ULNRC- 05206

**DOCKET NUMBER 50-483
CALLAWAY PLANT
UNION ELECTRIC COMPANY
LICENSE AMENDMENT REQUEST OL 1258
REVISION TO TECHNICAL SPECIFICATION 3.7.3,
"MAIN FEEDWATER ISOLATION VALVES (MFIVs)"**

**LICENSE AMENDMENT REQUEST OL 1258
REVISION TO TECHNICAL SPECIFICATION 3.7.3,
"MAIN FEEDWATER ISOLATION VALVES (MFIVs)"**

MARKUP OF TECHNICAL SPECIFICATION PAGES

Figure 3.7.3-1 (Page 1 of 1)
 MFIV Stroke Time Limit vs Steam Generator Pressure
 3.7-8a

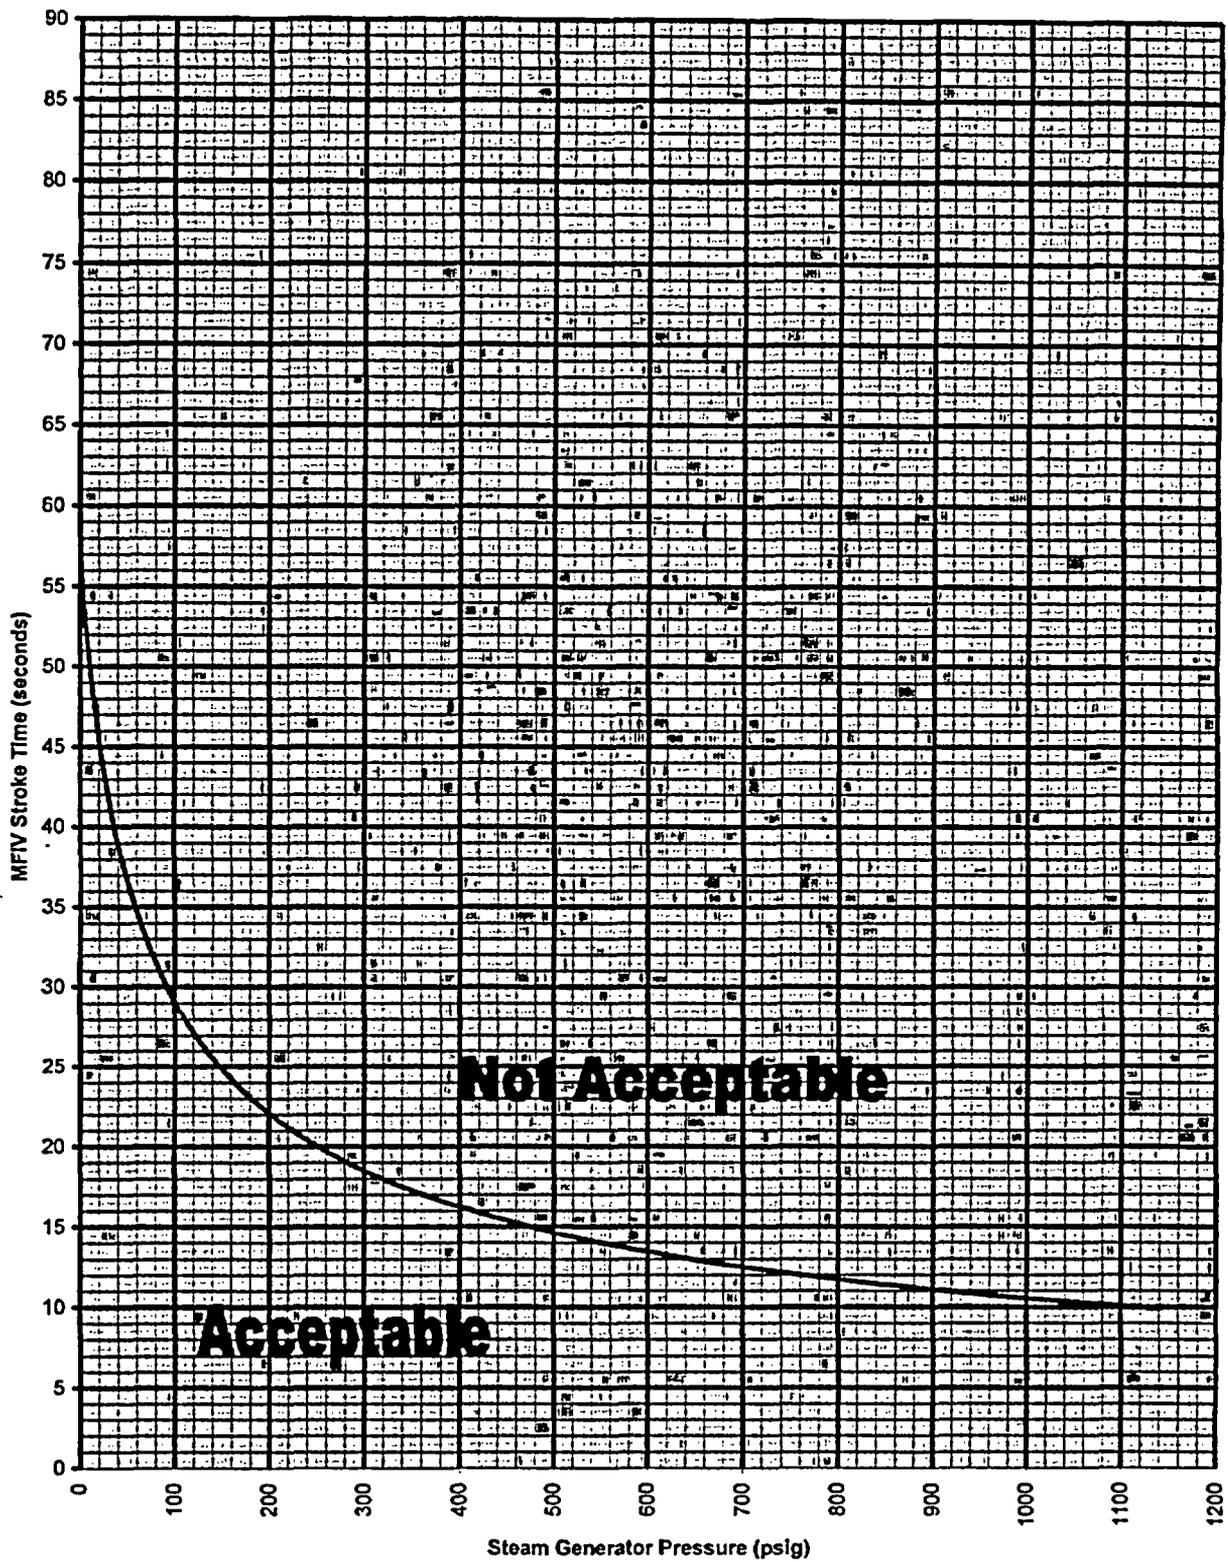
Proposed new SR 3.7.3.3 would specify a stroke-time test requirement more appropriate to the MFIV system-medium actuator design and its associated system-pressure dependent stroke time. Specifically, the statement of proposed SR 3.7.3.3 requires verifying that the closure time for each MFIV is within the limits of Figure 3.7.3-1, which is a new figure that is being added to TS 3.7.3. Figure 3.7.3-1 is a curve of the MFIV isolation time limit as a function of steam generator pressure, in lieu of a single-valued stroke time limit as currently specified. The frequency for performing this surveillance, i.e., for verifying that the MFIV isolation (closure) time is within the limits of Figure 3.7.3-1, would continue to be in accordance with the Inservice Testing Program.

AmerenUE is proposing a revised Technical Specification that will capture the dependency on steam generator pressure of the MFIV stroke time. The proposed TS change provides the requirement that the closure time for each MFIV is within the limits of Figure 3.7.3-1. Figure 3.7.3-1 is a curve of the MFIV isolation time limit as a function of steam generator pressure and provides a variable stroke time for the MFIVs. Having a stroke time limit requirement that is dependent on steam generator pressure enables performance of the required MFIV surveillance at any particular operating condition bounded by the curve.

After receipt of the amendment requested per this application, implementation of the amendment will make Figure 3.7.3-1 effective as the acceptance criterion for the MFIV stroke time test(s) required per SR 3.7.3.3. Proposed Figure 3.7.3-1 is a bounding curve that provides the required MFIV stroke time limit as a function of secondary system pressure. As described in Section 3.0, proposed Figure 3.7.3-1 is based on a performance curve that was established for the MFIVs and validated, in part, by field testing of the valves at various pressures.

Nevertheless, it is AmerenUE's intent to perform stroke-time "baseline" testing of the MFIVs at several pressure values over the test pressure range. This will validate the MFIV performance curve (on which the curve of Figure 3.7.3-1 is based) under actual plant conditions (using only a single actuation train to stroke each MFIV). This baseline testing will be completed prior to implementation of the requested amendment.

SR 3.7.3.3 Verify the closure time of each MFIV is within the limits of Figure 3.7.3-1.	In accordance with the Inservice Testing Program
---	---
